SERVICE BULLETIN

N° 139-710

DATE: July 15, 2022

ATA 23 - SATCOM FLIGHTCELL IMPROVEMENT

Figure 1

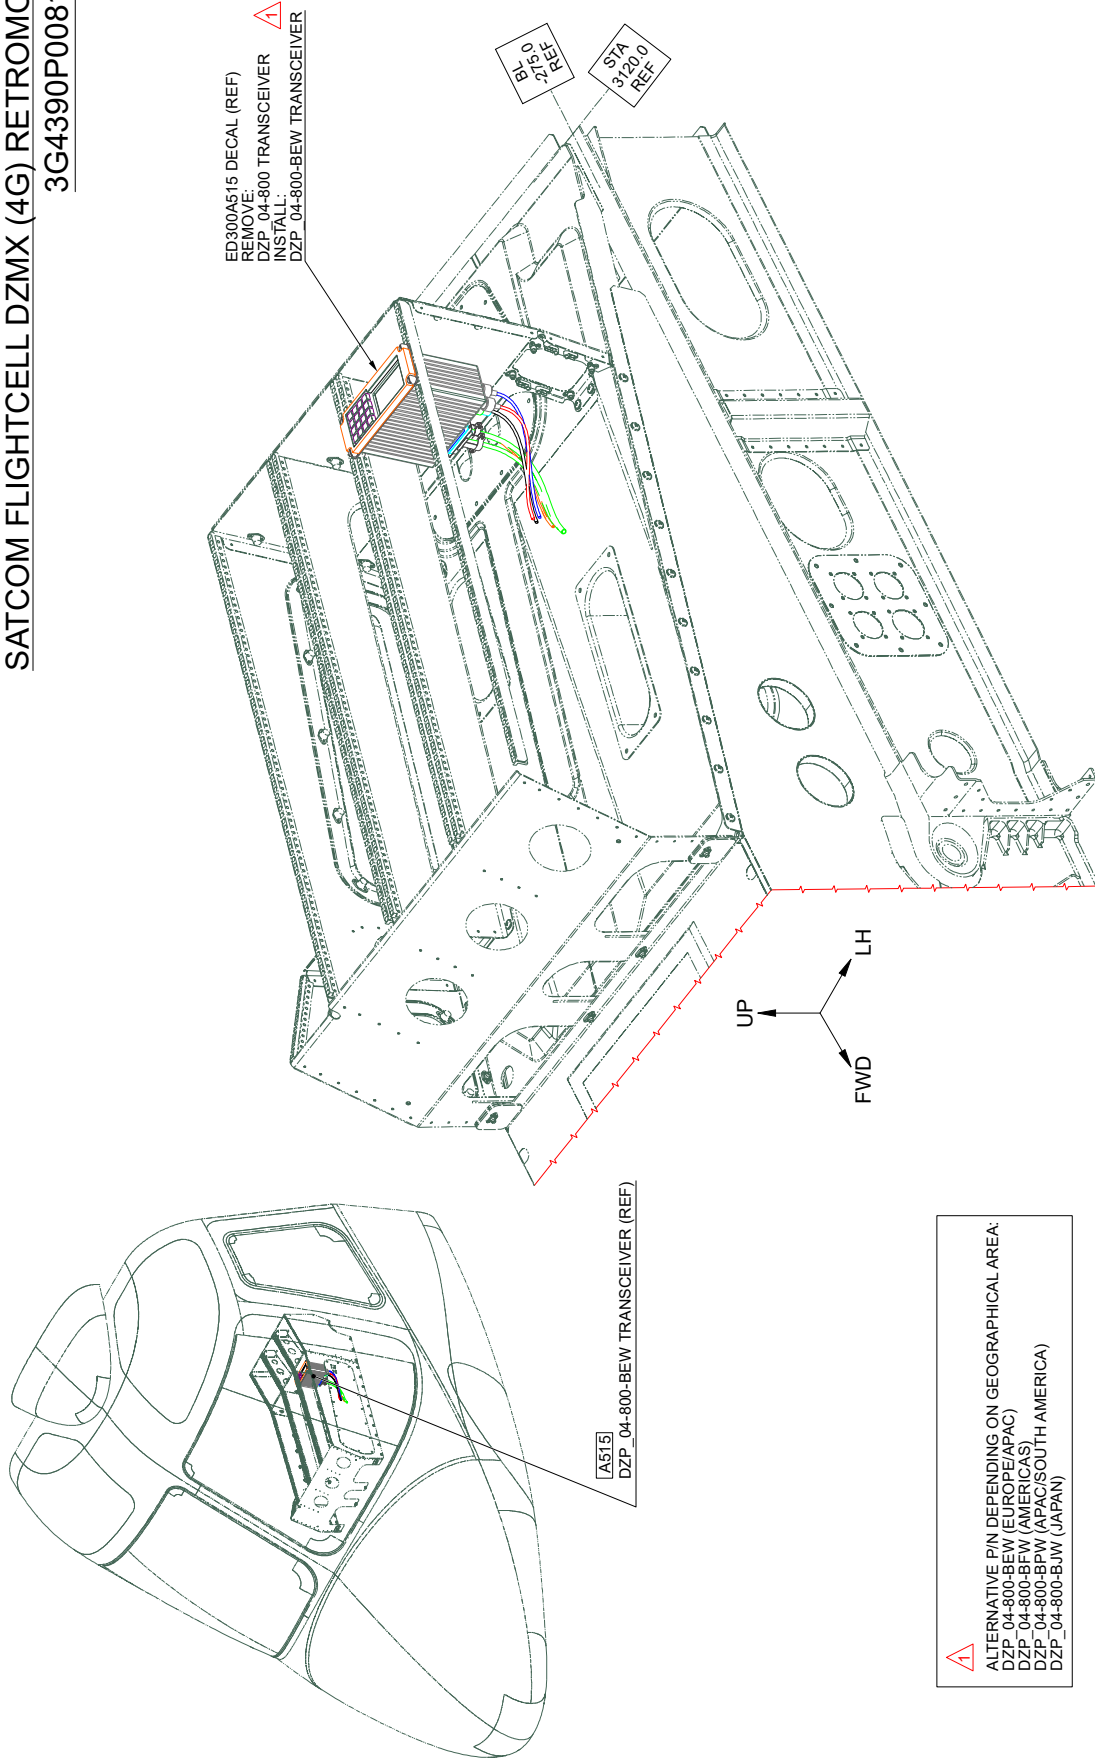
1. In accordance with AMP DM 39-A-00-20-00-00A-120A-A, prepare the helicopter on ground for a safe maintenance. Disconnect the battery, all electrical power sources and/or the external power supply.
2. In accordance with AMP DM 39-A-06-41-00-00A-010A-A and with reference to Figure 1, remove all external panels, internal panels and internal liners as required to gain access to the area affected by the installation and perform Satcom Flightcell DZMX (4G) retromod P/N 3G4390P00812 as described in the following procedure:
 - 2.1 With reference to Figure 1, remove the transceiver P/N DZP-04-800 from the interseat console.

- 2.2 With reference to Figure 1 and in accordance with AMP DM 39-E-23-97-01-00A-720A-A, install the transceiver

P/N DZP-04-800-BEW on the interseat console.

Figure 2

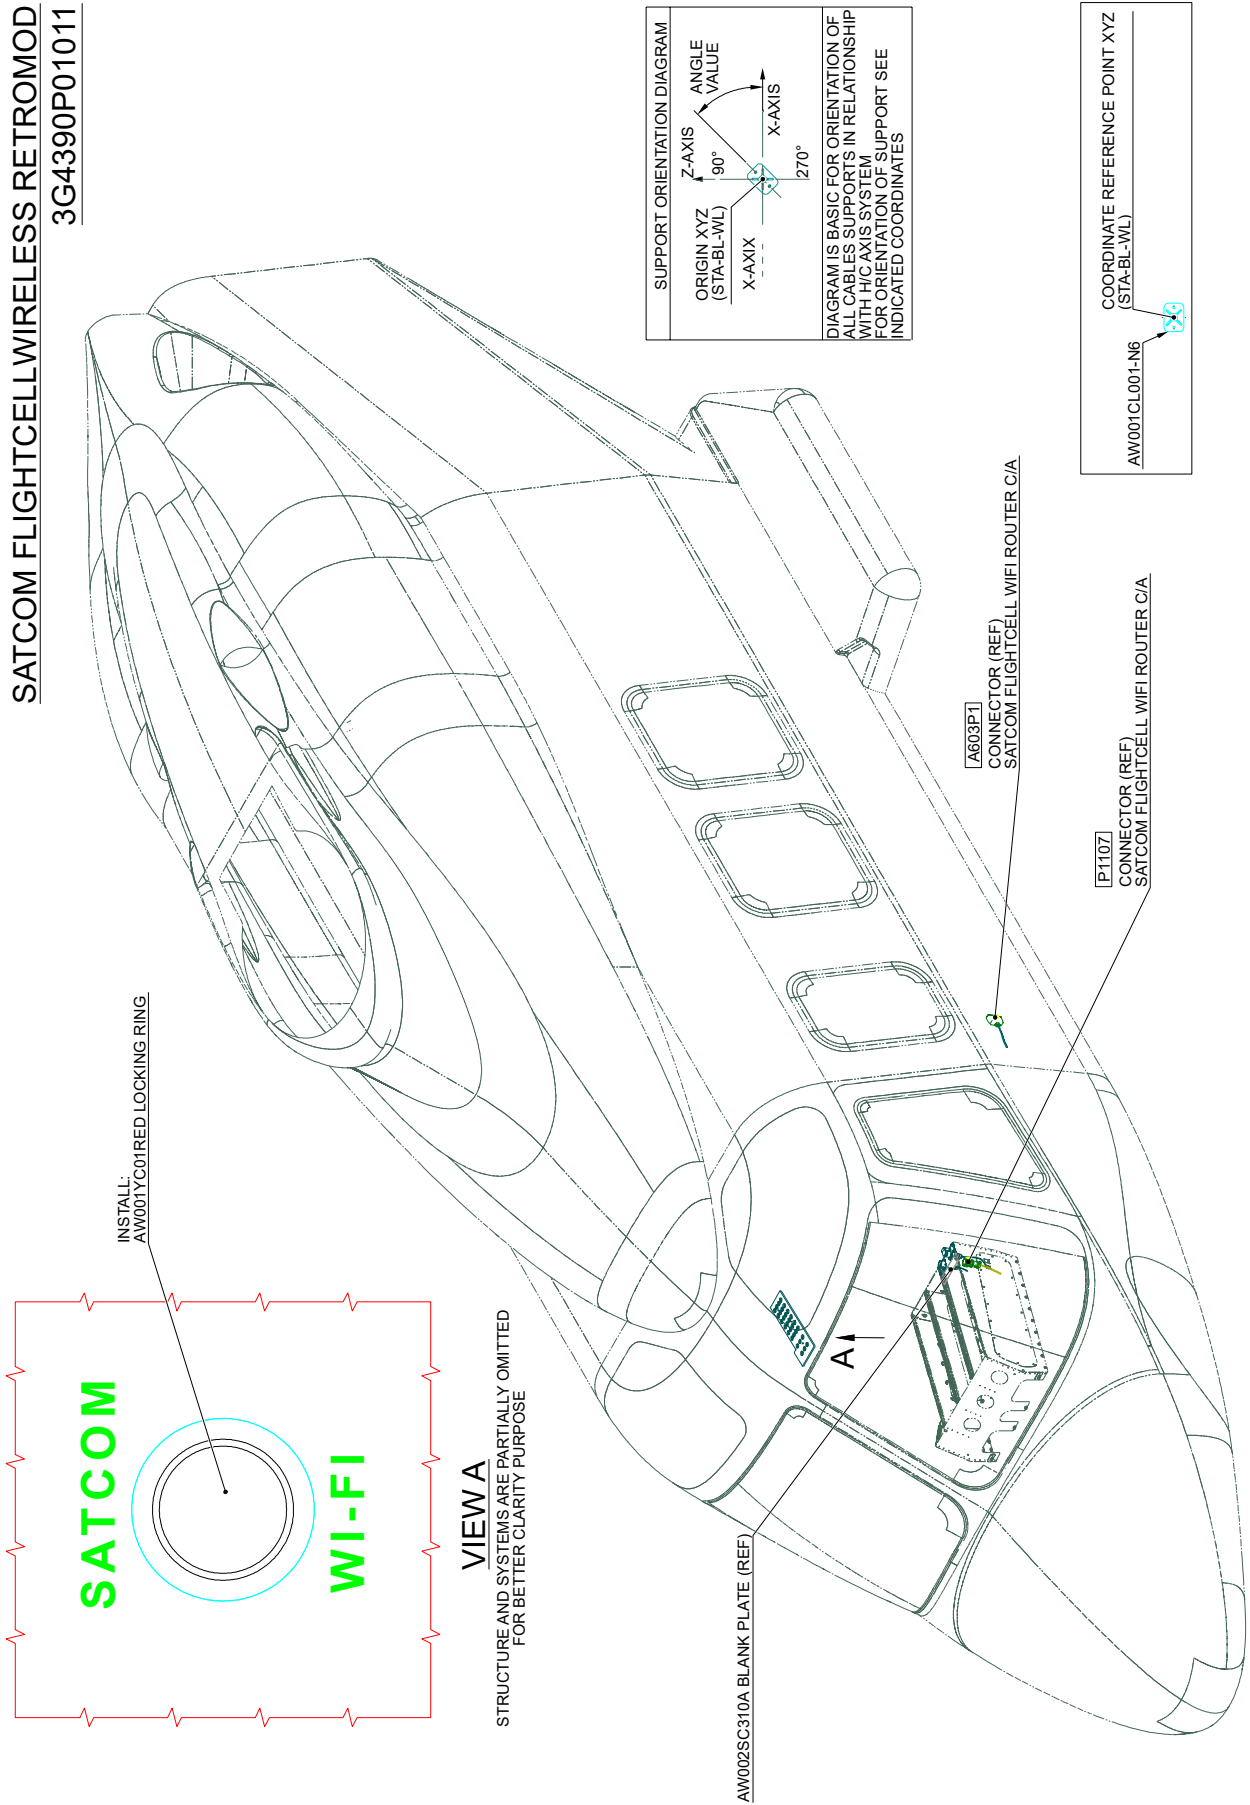
- 2.1 With reference to Figure 2 View A, install the locking ring P/N AW001YC01RED on the CB panel.
 - 2.2 With reference to Figure 3, remove the Wi-Fi router dummy plate P/N 3G5315P03751 and install blank plate P/N AW002SC310A.

Figure 3

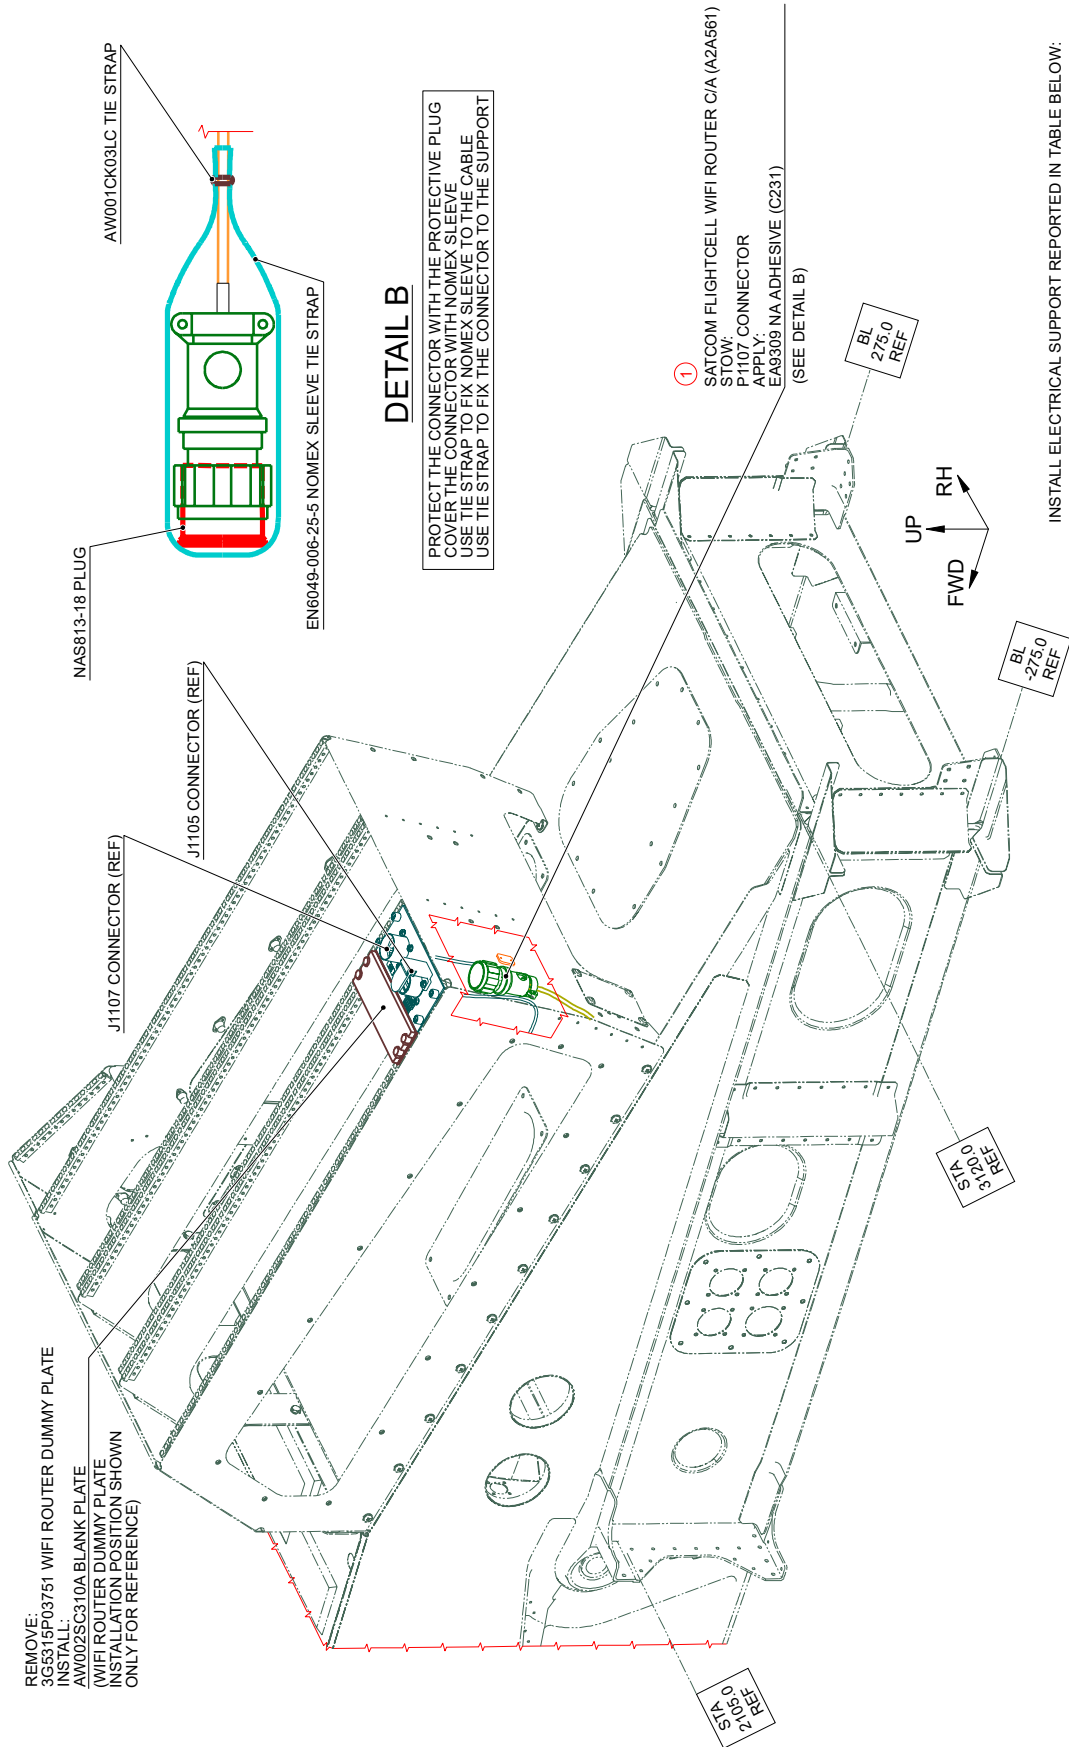
- 2.3 With reference to Figure 3, disconnect the connector P1107.
 - 2.4 With reference to Figure 3, install the support P/N AW001CL001-N6 by means of Adhesive Hysol EA9309 NA (C231) on the interseat console.

- 2.5 With reference to Figure 3 Detail B, stow the connector P1107 with protective plug P/N NAS813-18, fibre sleeve (Nomex) P/N EN6049-006-25-5 and tie strap P/N AW001CK03LC.

LOCATION NUMBER	PART NUMBER	STA	BL	WL	ORIENTATION
①	AW001CL001-N6	2869	-199	1317	90°

Figure 4

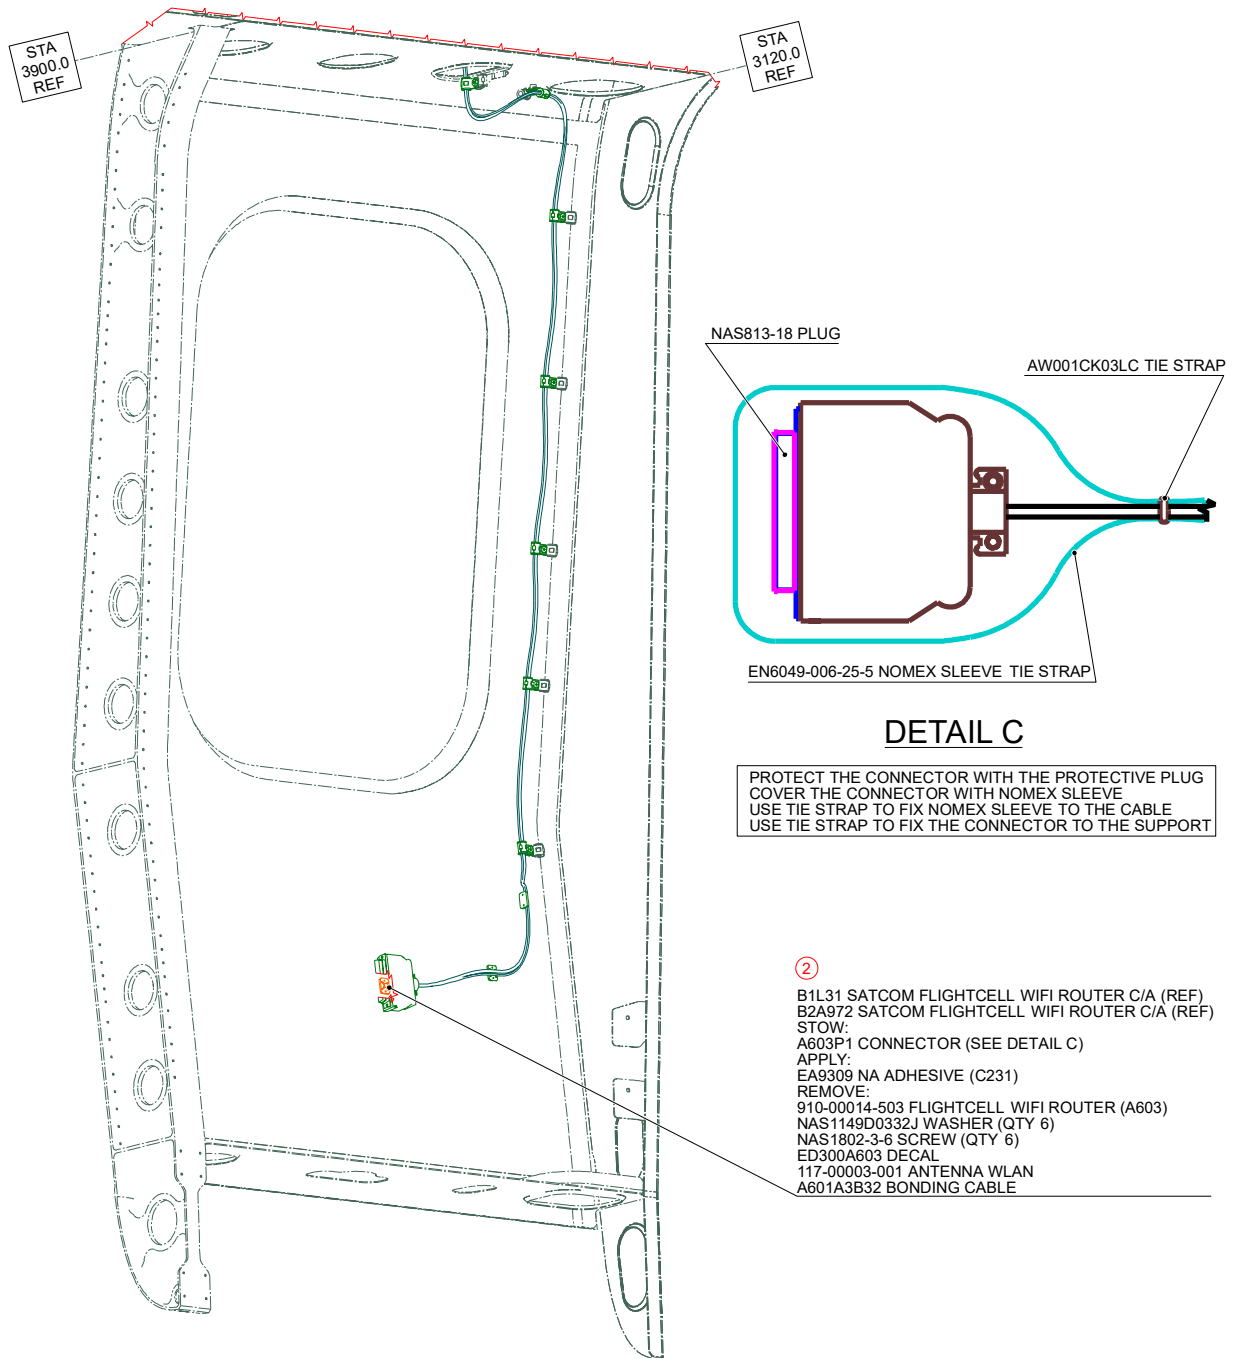
- 2.6 With reference to Figure 4, disconnect the connector A603P1 from the Wi-Fi router P/N 910-00014-503.
 - 2.7 With reference to Figure 4 and in accordance with AMP DM 39-C-23-98-01-00A-520A-K, remove the Wi-Fi router P/N 910-00014-503 (including Wi-Fi antenna P/N 117-00003-001) from the structure by means of n°6 screws P/N NAS1802-3-6, n°6 washers P/N NAS1149D0332J and the bonding C/A P/N A601A3B32, and remove the decal P/N ED300A603.

- 2.8 With reference to Figure 4 Detail, install the support P/N AW001CL001-N6 by means of Adhesive Hysol EA9309 NA (C231).
 - 2.9 With reference to Figure 4 Detail C, stow the connector A603P1 with protective plug (if available), fibre sleeve (Nomex) P/N EN6049-006-25-5 and tie strap P/N AW001CK03LC.

LOCATION NUMBER	PART. NUMBER	STA	BL	WL	ORIENTATION
②	AW001CL001-N6	3460	-1078	1310	0°
